AMENDMENT - INVITATION TO TENDER

Title-Sujet: Construction – Wabasca-Desmarais Detachment	
Solicitation No. - No. de l'invitation 201804138	Date 1 février, 2018
Client Reference No. - No. De Référence du Client 201804138	Amend No.- No. du modif. 007
GETS Reference No. - No. de Référence de SEAG 201804138	
Solicitation Closes –L'invitation prend fin at - à 16 :00 ET on - le Feb. 6th, 2018	
F.O.B. - F.A.B. Destination	
Address Enquiries to: - Adresser toutes questions à: jordan.mckenna@rcmp-grc.gc.ca	
Telephone No. - No de telephone 613.843.5518	Fax No. - N° de FAX:
Destination of Goods, Services, and Construction: Destinations des biens, services et construction:	
Delivery Required - Livraison exigée:	Delivery Offered - Livraison proposée
Name and title of person authorized to sign on behalf of Vendor/Firm Nom et titre de la personne autorisée à signer au nom du fournisseur/de l'entrepreneur

ADDENDUM No. 05

**GOVERNMENT OF CANADA
WABASCA-DESMARAIS GOVERNMENT BUILDING**

1 ELECTRICAL ROOF PLAN
E2.1 SCALE: 1:100

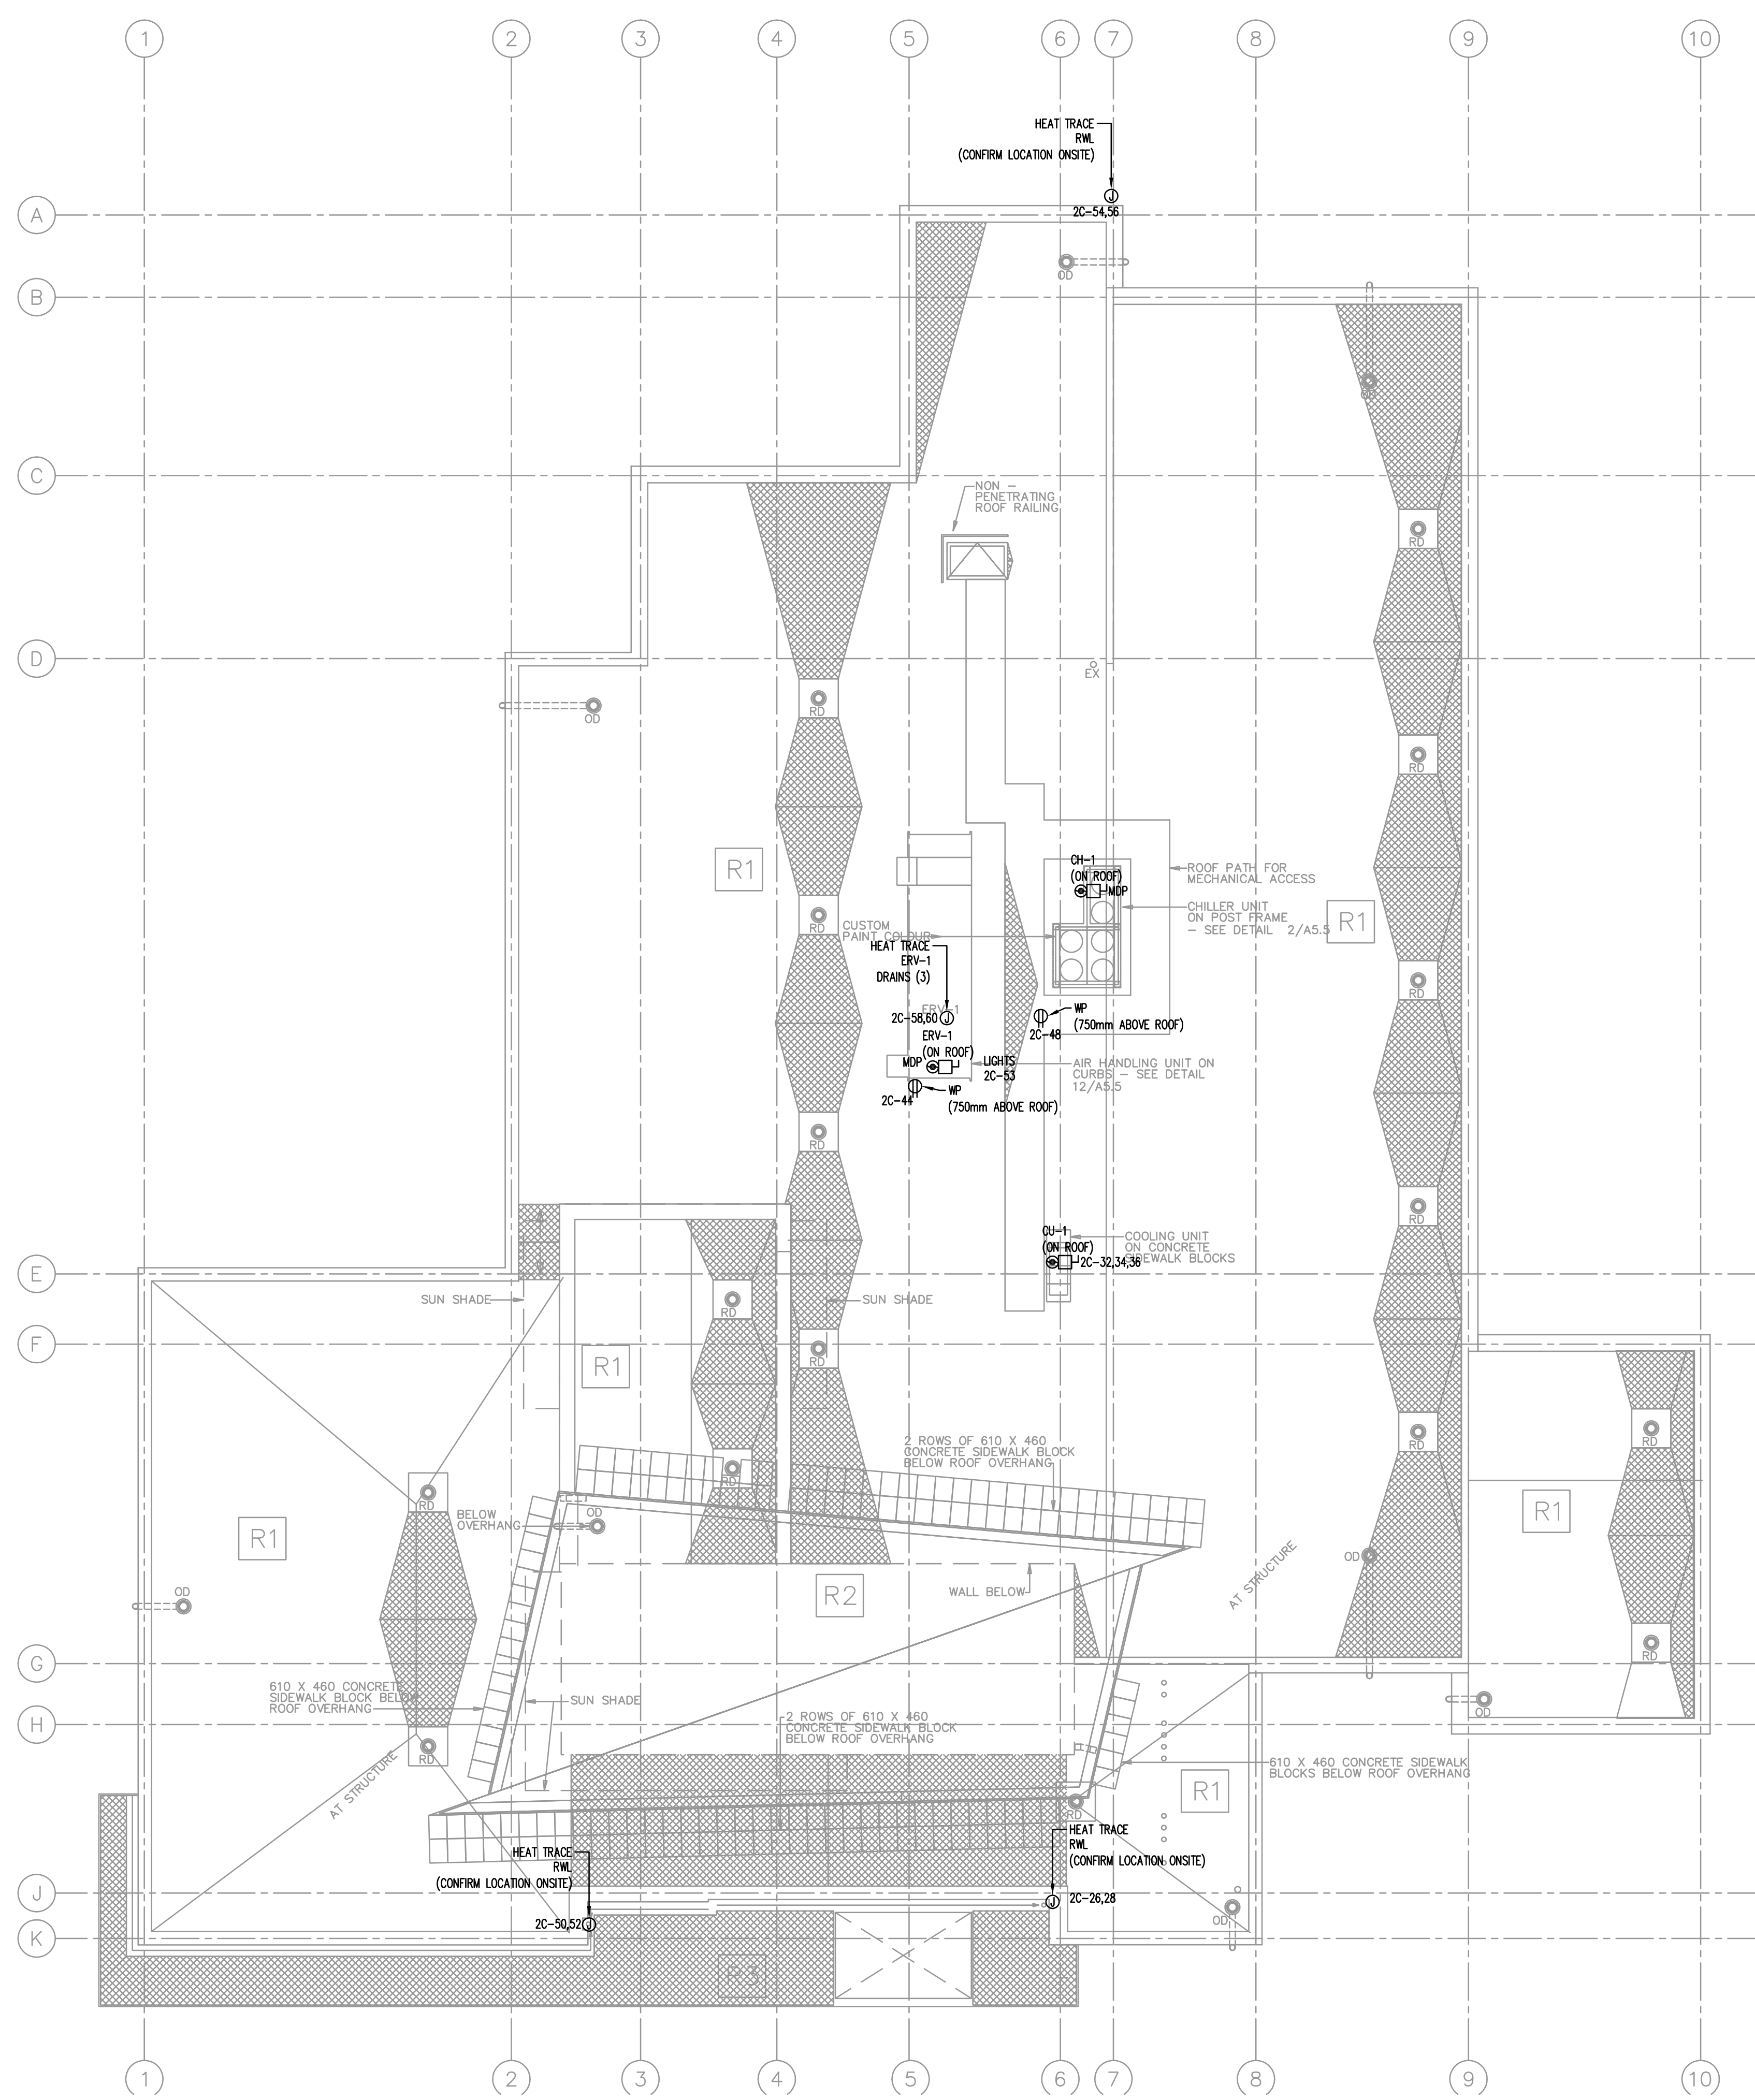
REVISE: Drawing has been re-issued with this addendum to address coordination with architectural plans.

1 LIGHTING PLAN
E3.0 SCALE: 1:100

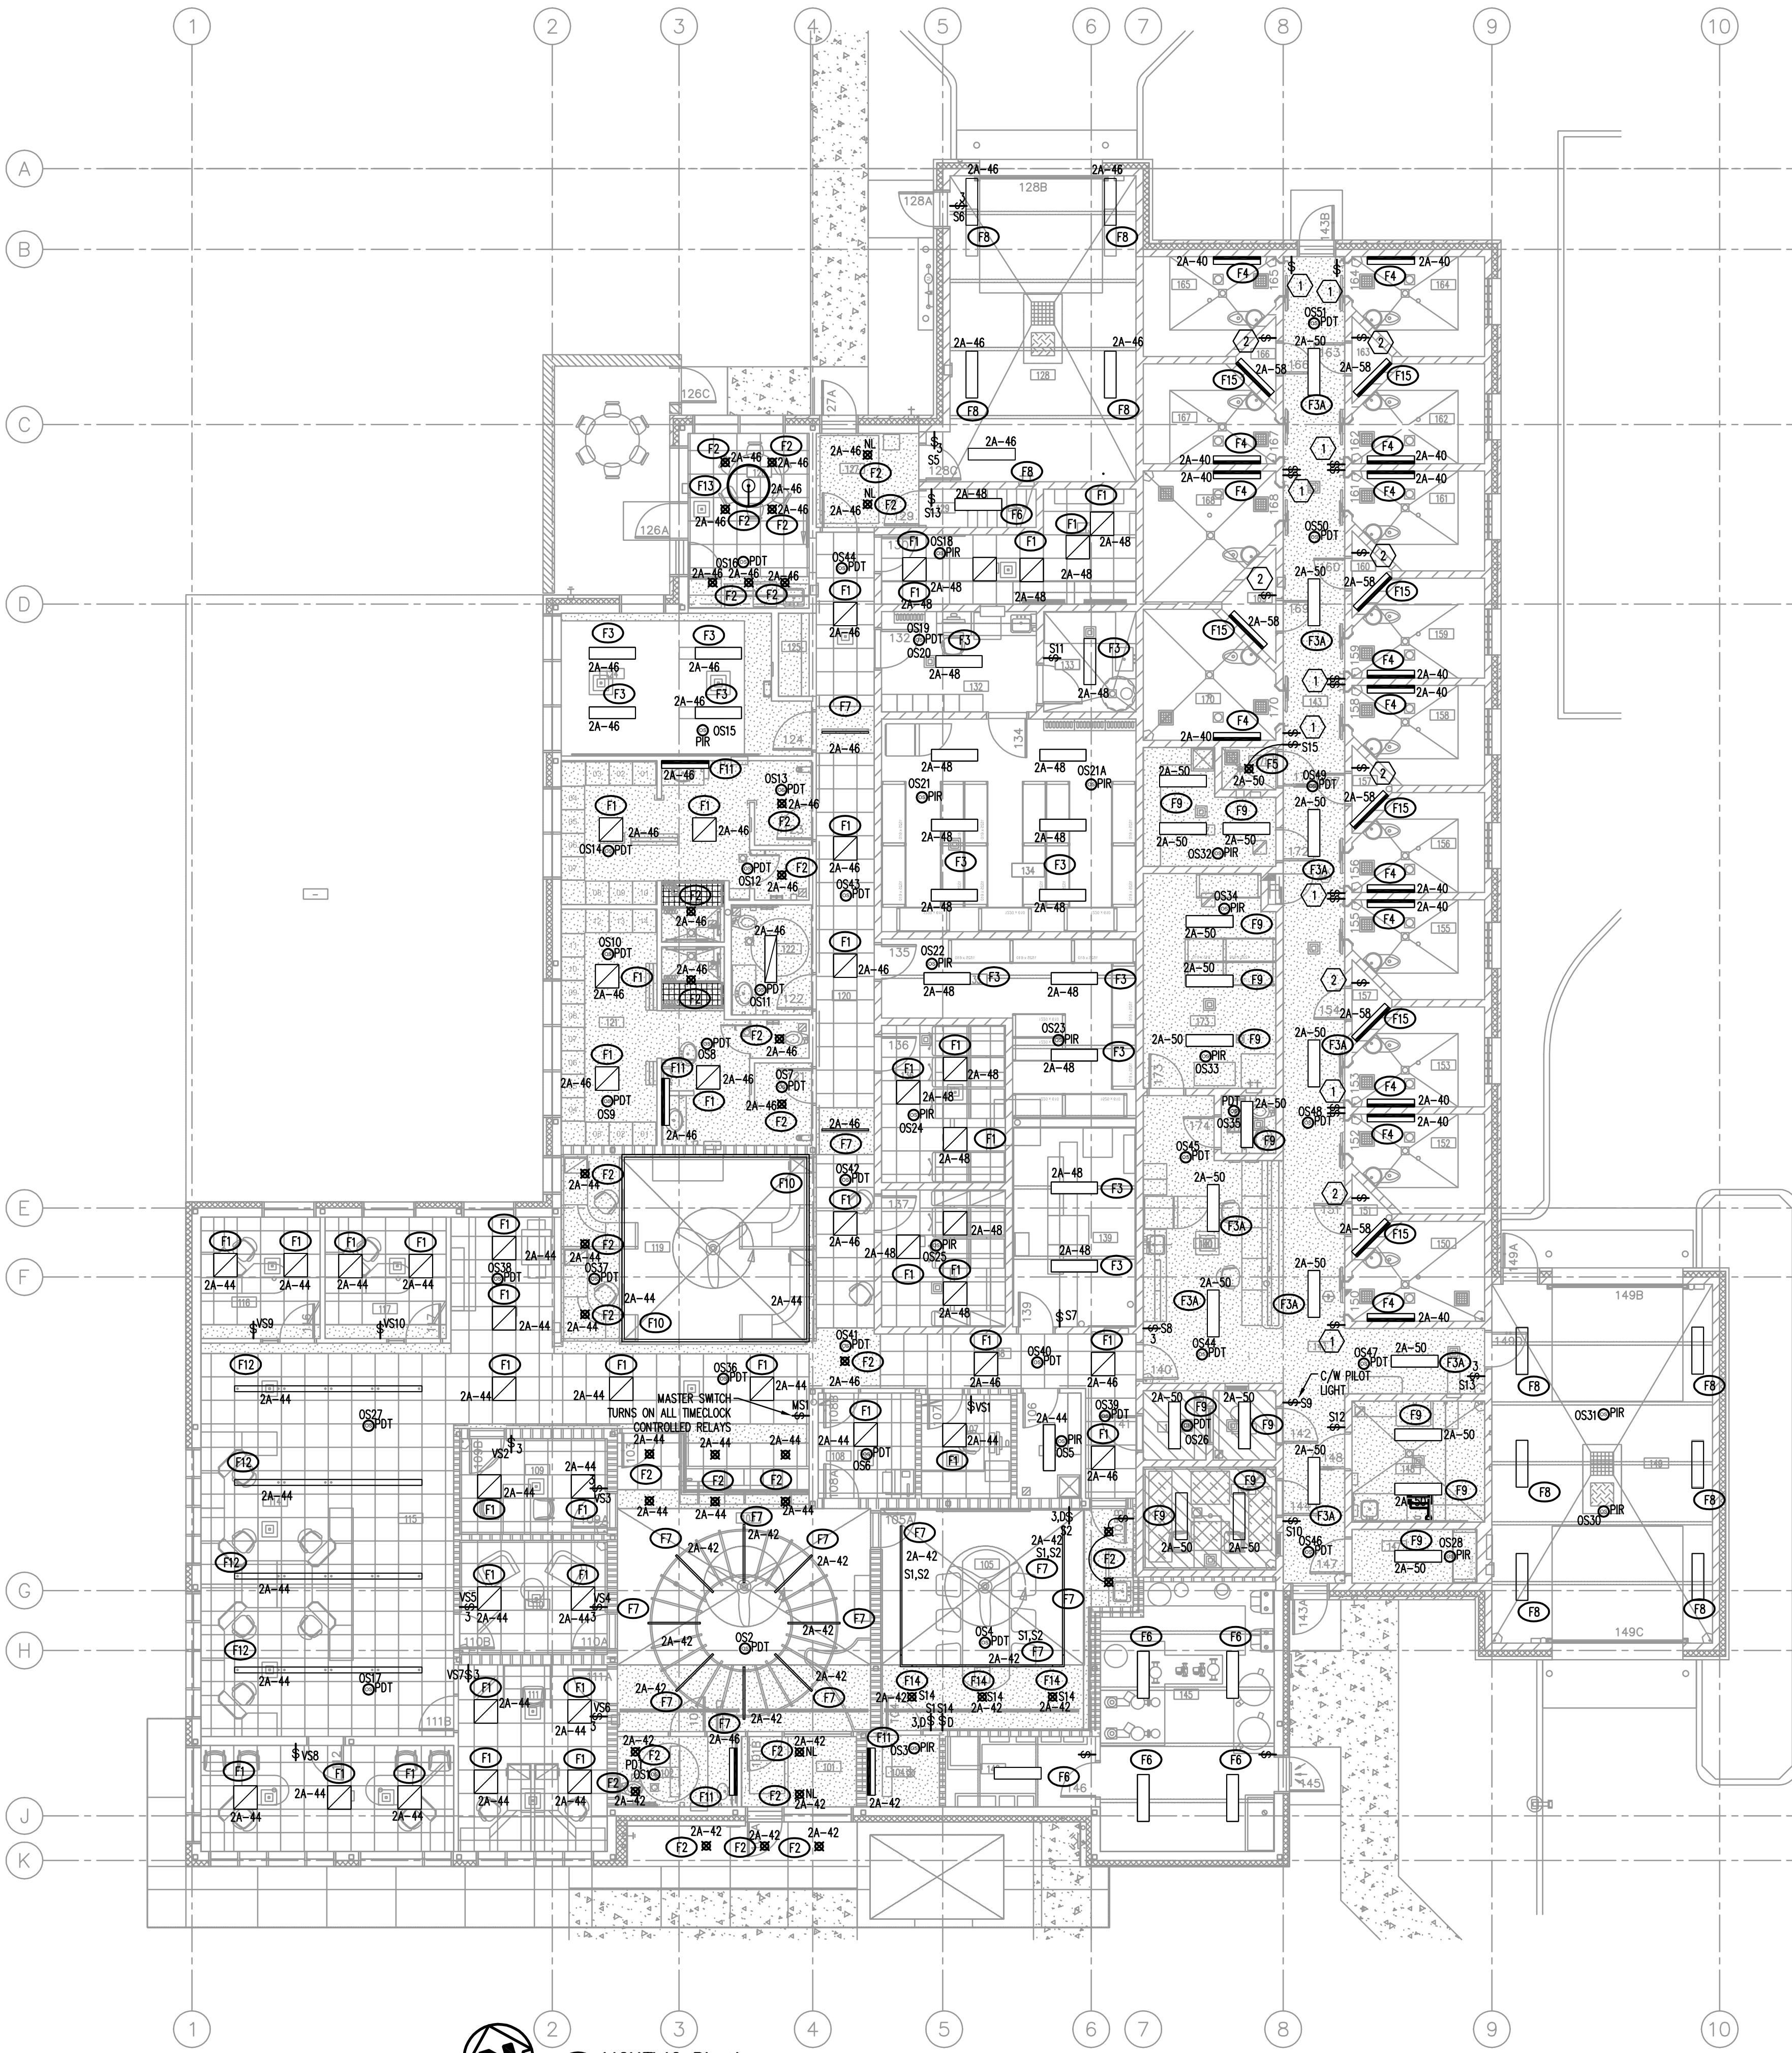
REVISE: Drawing has been re-issued with this addendum to address coordination with the architectural backgrounds, mainly aligning the wall arrangement with the ceiling.
